AUSTIN ROVER

BULLETIN
MAESTRO TECHNICAL

DOOR HINGE WELDS - INCOMPLETE

GEARBOX - CHANGE TO TYPE FITTED

fig 5/1

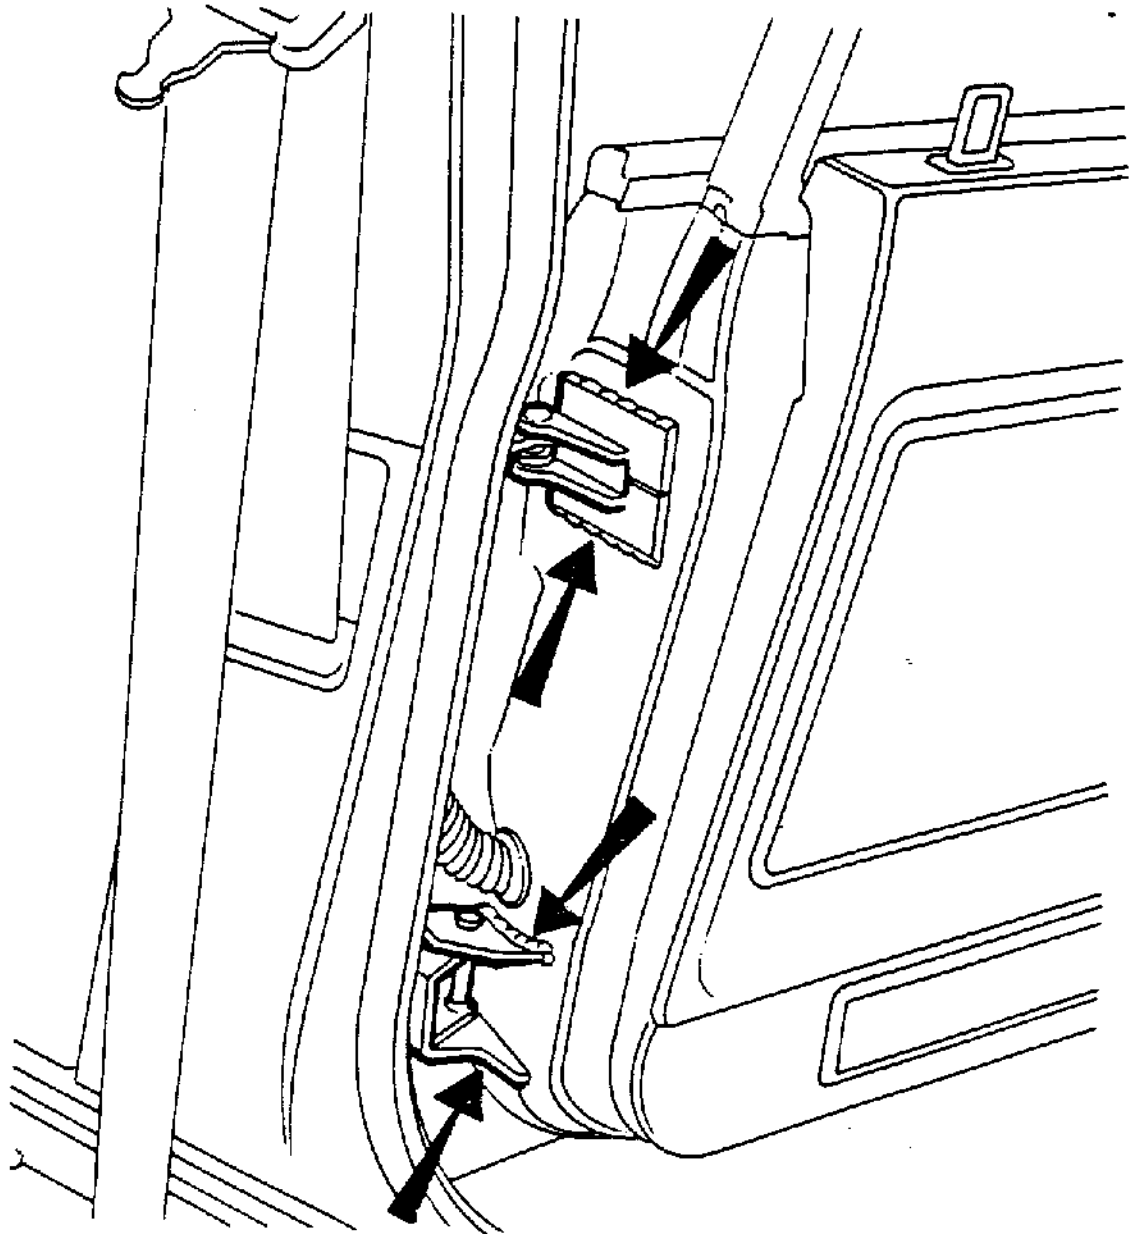
Welds between hinges and doors imperfect or incomplete.

Robot welder not operating correctly.

- 1 Examine welds (arrowed in illustration) between the hinges and the door on all four passenger doors (two doors only on van) and the door. Look for missing welds and for any weld in which the filler metal has not made a proper bond with the door panel.
- 2 Any missing or suspect weld should be dealt with as follows:
 - a. remove trim pad from door and disconnect wiring, where fitted.
 - b. remove door from car.
 - c. ensure that nothing within door will be damaged during welding.
 - d. use mechanical means, e.g. small rotary wire brush,

Examine welds as described below and re-weld as necessary.

to remove paint from area to be welded and make repair as necessary, using CO2 welding.

- e. clean off welded area, degrease and repaint using etch primer and normal repainting process. Treat similarly bare area on body where hinges are bolted and mating faces of hinges.
- f. treat inside of door where hinges are attached with Unipart cavity wax.
- g. refit door to car and adjust as necessary.
- h. make good paint damage to bolt heads.
- i. re-assemble door.
